# Access Compliance Report

### (Curb Ramps)

Intersection ID: 13442	Main Street: MORRIS_FIELD_DR	Cross Street: AIRPORT_CENTER_PY	Location: S
ADA ID: 30664BC40BB9	Ramp Type: PerpDiag	Initial Pass/Fail: Fail	Overall Compliance: No
Severity Score: 10			
Codes/Mitigation Info/Possible Solution		Field Measurements/Component Compliance

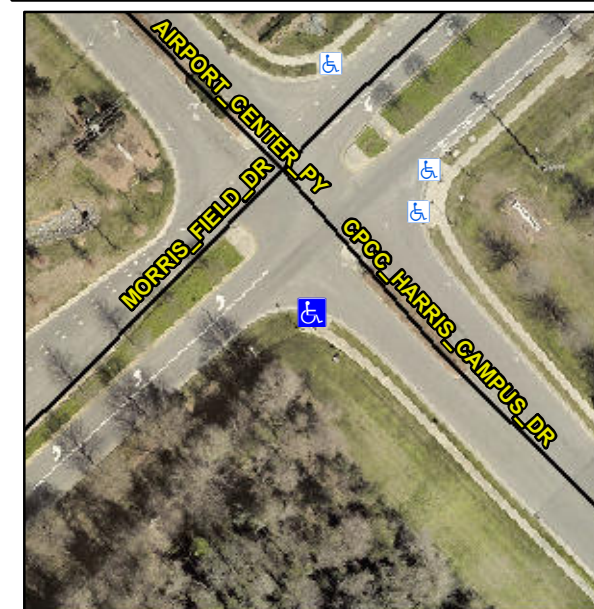
**Not Found, R304.5.1, R304.5.3**

Compliance	Description	Data	Compliance	Description	Data
N/A	Ramp Length (in)	59.0	Yes	Ramp Slope (%)	7.9
No	Ramp Width (in)	47.0	No	Ramp XSlope (%)	3.7
N/A	Flare Type LT	N/A	N/A	Flare Type RT	N/A
N/A	Flare Slope LT (%)	N/A	N/A	Flare Slope RT (%)	N/A
N/A	Flare Traversable LT?	N/A	N/A	Flare Traversable RT?	N/A
N/A	Landing Length (in)	N/A	N/A	DWS Provided?	N/A
N/A	Landing Width (in)	N/A	N/A	DWS Contrast?	N/A
N/A	Landing Slope (%)	N/A	N/A	DWS Length (in)	N/A
N/A	Landing X Slope (%)	N/A	N/A	DWS Full Width?	N/A
N/A	Landing Curb? (Y/N)	N/A	N/A	DWS Offset (in)	N/A
N/A	Shared Landing?	N/A			
N/A	Gutter Ponding?	N/A	N/A	Gutter Slope (%)	N/A
N/A	Gutter Lip Ht (in)	N/A	N/A	Gutter X Slope (%)	N/A
N/A	Painted X Walk1?	No	N/A	Painted X Walk2?	No
	X Walk 1 Direction	To NE		X Walk 2 Direction	To NW
N/A	X Walk 1 Width (in)	N/A	N/A	X Walk 2 Width (in)	N/A
	X Walk 1 Slope (%)	0.8		X Walk 2 Slope (%)	3.9
	X Walk 1 X Slope (%)	3.9		X Walk 2 X Slope (%)	0.1

**Remove & Replace Curb Ramp With Two New Directional Ramps or Equivalent.**
